FX12 Board Errata

Revision: August 16, 2006

The Diligent FX12 board (the FX12) is an integrated circuit development platform for Xilinx's Virtex-4 FX12 FPGA. This document describes modifications to the FX12 board that are made after the original manufacturing operation.

Item #1

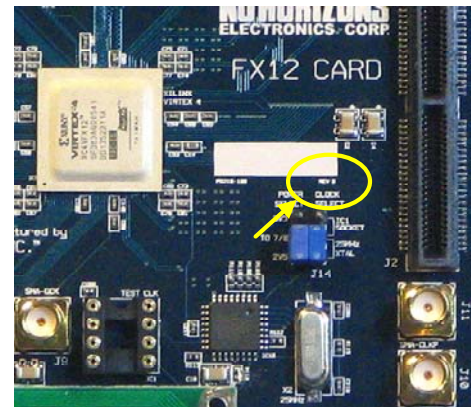
The two JTAG data signals (TDI and TDO) routed to the parallel-4 connector on the FX12 board were swapped, rendering the parallel-4 connector unusable. These signals are not swapped for the parallel-3 6-pin connector; this problem only affects the parallel-4 connector.

This item affects only Rev B boards.

Boards have been modified by Diligent to correct this problem. The TDI and TDO traces between the parallel-3 and parallel-4 connectors were cut, and jumpers added to connect the traces correctly. This modification has been validated and tested on all boards. No functional problems exist.

This fix will be incorporated into the PCB for Rev C boards.
